Request for Additional Information for General Electric – Morris Operation License Renewal Application

General Electric Corporation
Morris Operation
Docket No. 72-1
SNM-2500

SECTION 1 -IDENTIFICATION OF SSCS SUBJECT TO AGING MANAGEMENT

**Basis for evaluating Structures, Systems and Components within the scope for license renewal.
(Figure 3.0-1)**

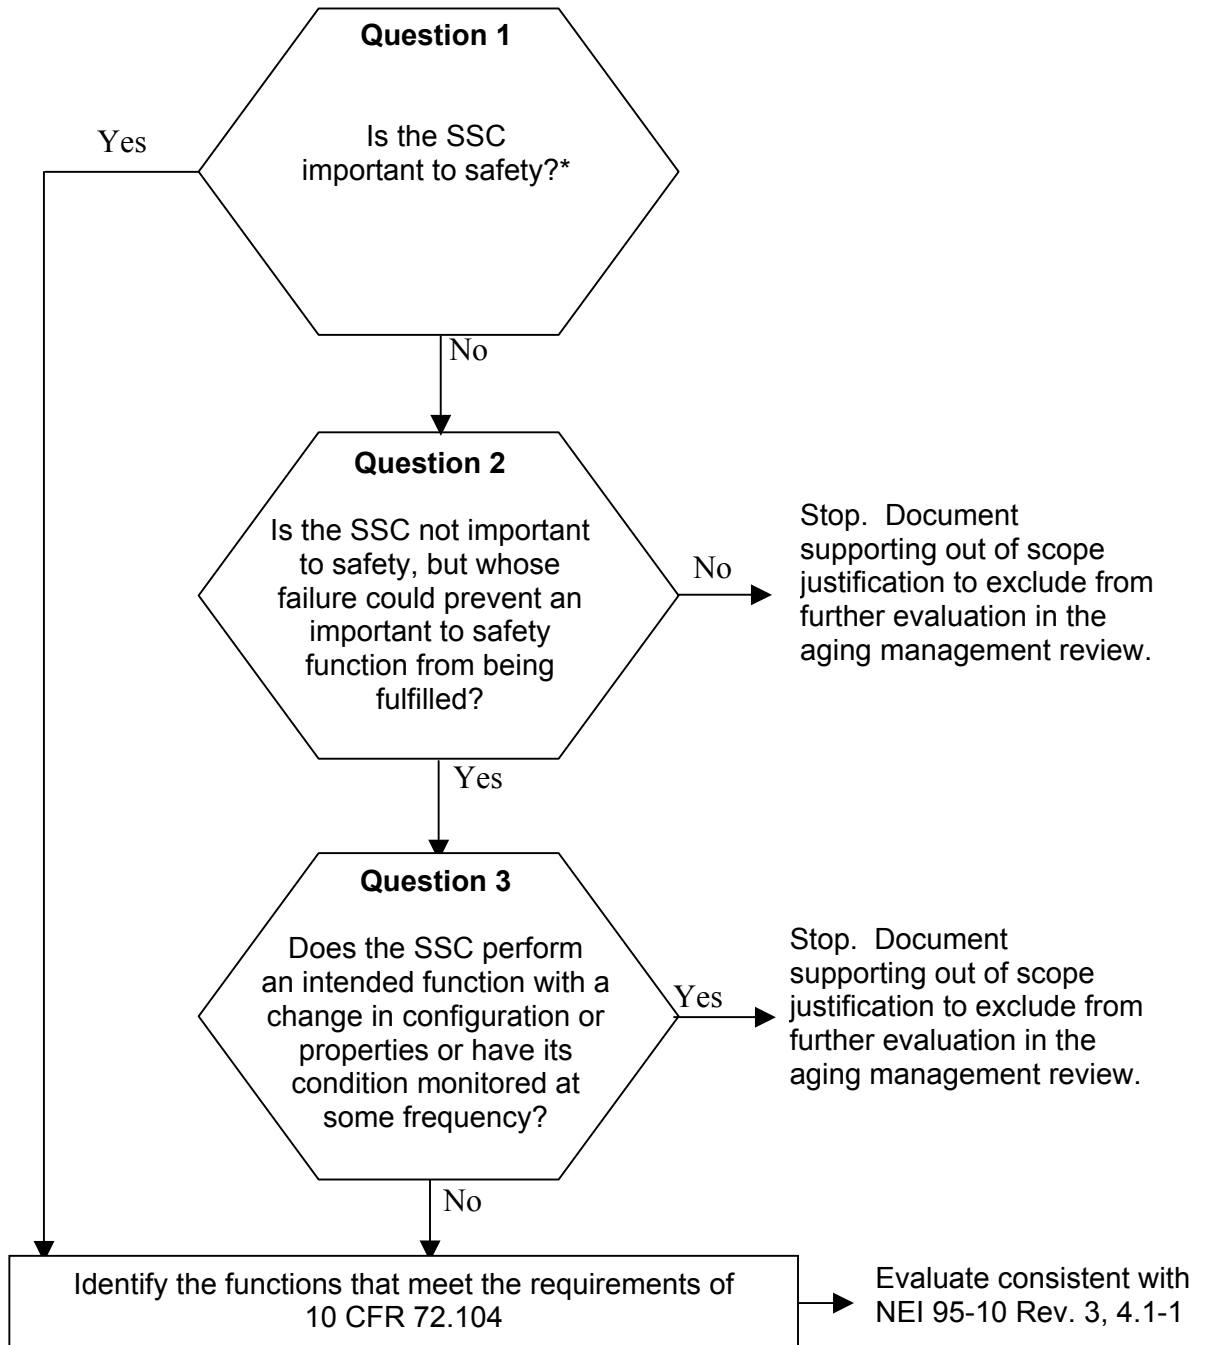
1-1 Provide a list of SSCs that are subject to an AMR and a list of SSCs that are not subject to an AMR. Describe the process used to determine the SSCs that are subject to an AMR.

The basis for evaluating Structures, Systems and Components within the scope for license renewal under 10CFR72 was developed consistent with NEI 95-10 Rev 3, Figure 3.0-1. The process developed is similar to the process described in the GALL report (NUREG 1801) and is consistent, where practical, with the application provided in support of the Surrey application for a dry storage ISFSI. This figure was modified to remove references to 10 CFR 54.4(a)(3) and incorporate guidance from the Surrey application for ISFSI site-specific license renewal.

For each Structure, System and Component in the Plant
Process the SSC through the following flow path using applicable information sources
consistent with NEI 95-10 Rev 3, Table 3.1-1

* Important to safety related SSCs are those which are relied upon to remain functional during and following design basis events to ensure the capability to prevent or mitigate the consequences of accidents that could result in off site exposure exceeding 10 CFR 72.104
